Video Conferencing

Subject: **FIRMWARE UPGRADE—VERSION 3.10**

Model: **PCS-4000, PCS-5000, PCS-5100**

Figure 1

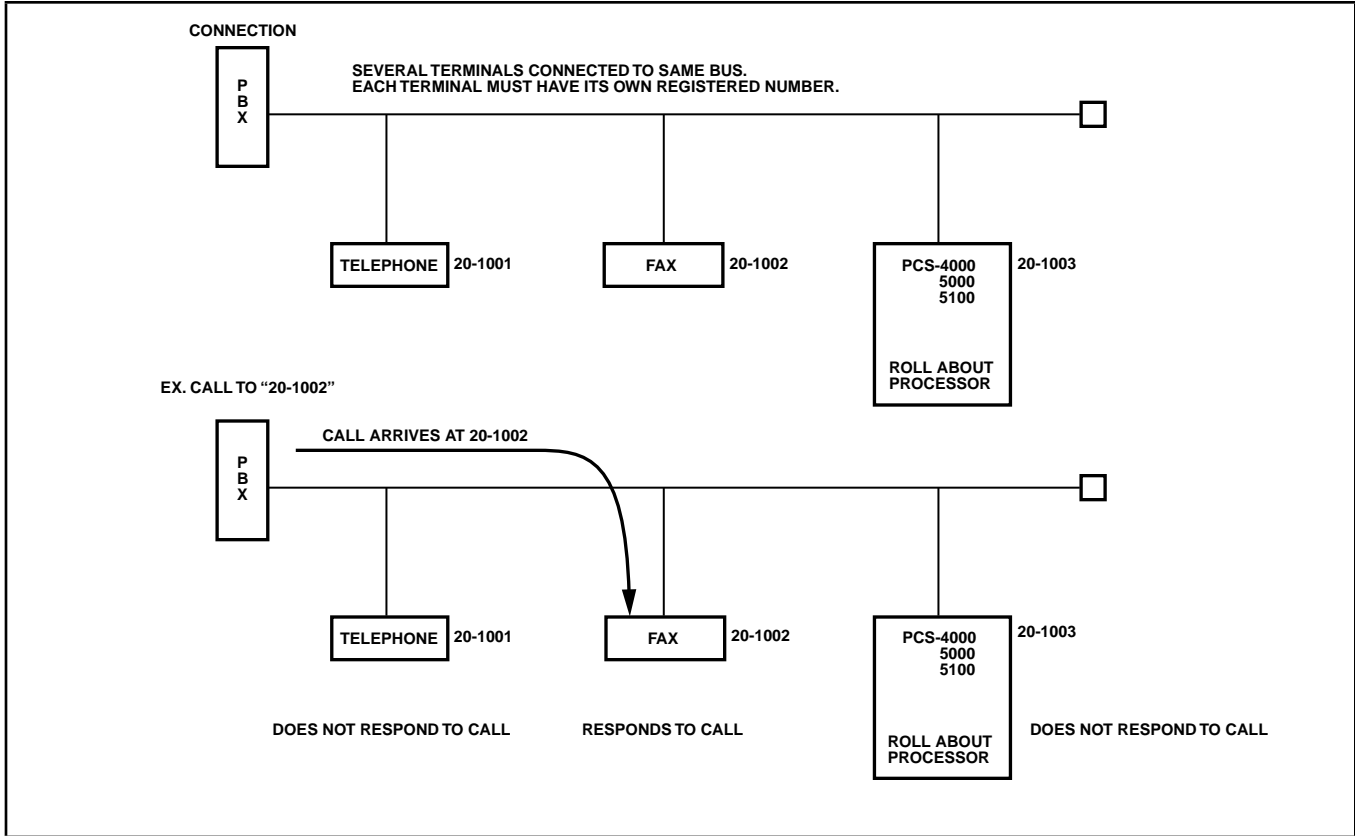
1. Multiple Subscriber Number Function is now supported in which a network provides different line numbers to several ISDN terminals connected to the same bus. In this version, the correct incoming call is responded to. In the previous version, a line number received from the network was not identified with an LDN (local directory number) registered in that line's terminal. Therefore, sometimes a call other than one from that terminal was responded to. (National ISDN-1 in USA did not experience this problem.) (See Figure 1.)

Figure 2

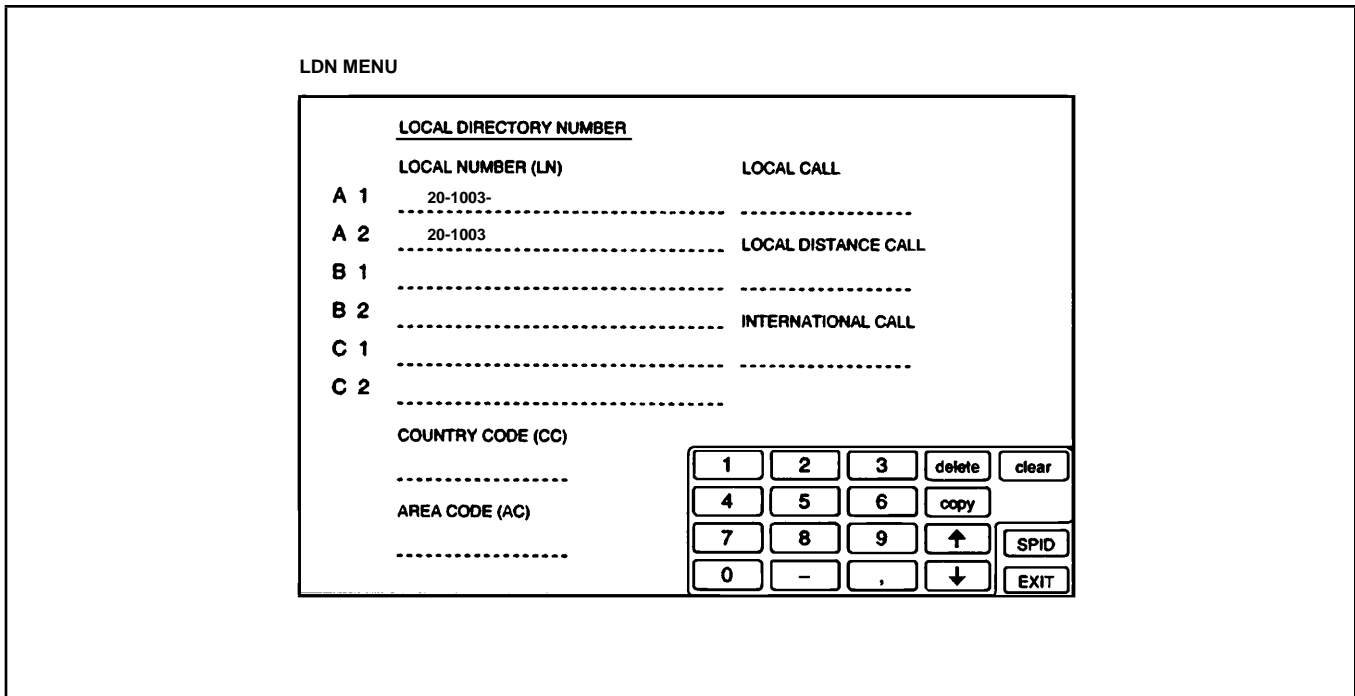
- Setup is as follows (see Figure 2):
 - a. To open the LDN menu, select the LDN icon in SYSTEM SETUP menu.
 - b. Enter line numbers to be connected to processor.
 - c. If the Multiple Subscriber Number function is used, enter “-” at the end of A1 entry. If the function is not used, do not enter “-”.

Figure 3

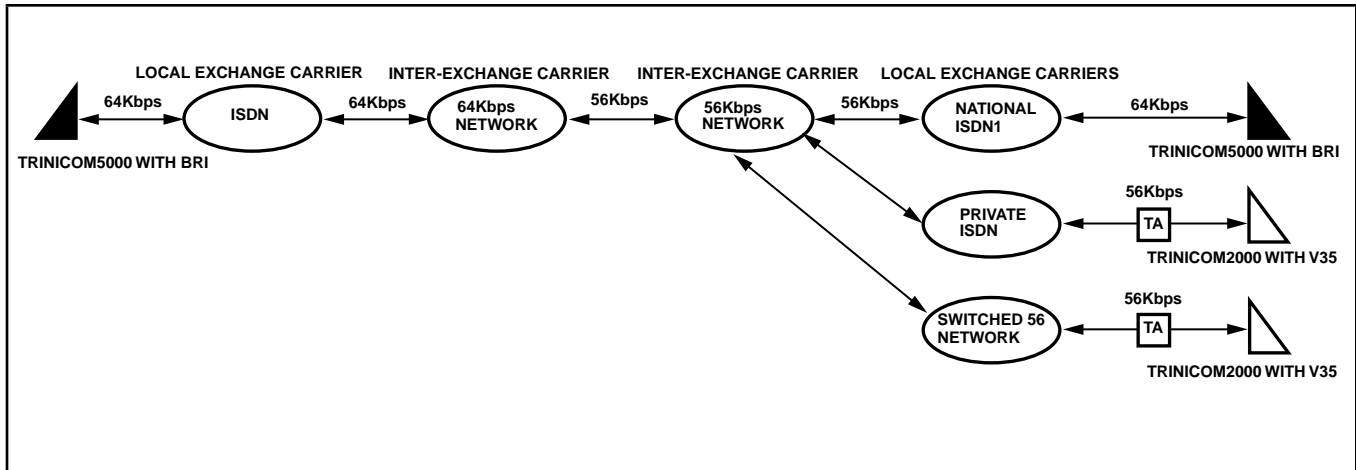
7. PCS-2000 Connection—The following have been corrected. (See Figure 3.)

- When connected to a PCS-2000, a camera at the end of the line could not be controlled from the "EASY MENU" in the PCS-5000.
- When making a mutual connection of a PCS-2000 in 56 kbps and a PCS-5000 in 64 kbps ISDN, audio and video were not output.
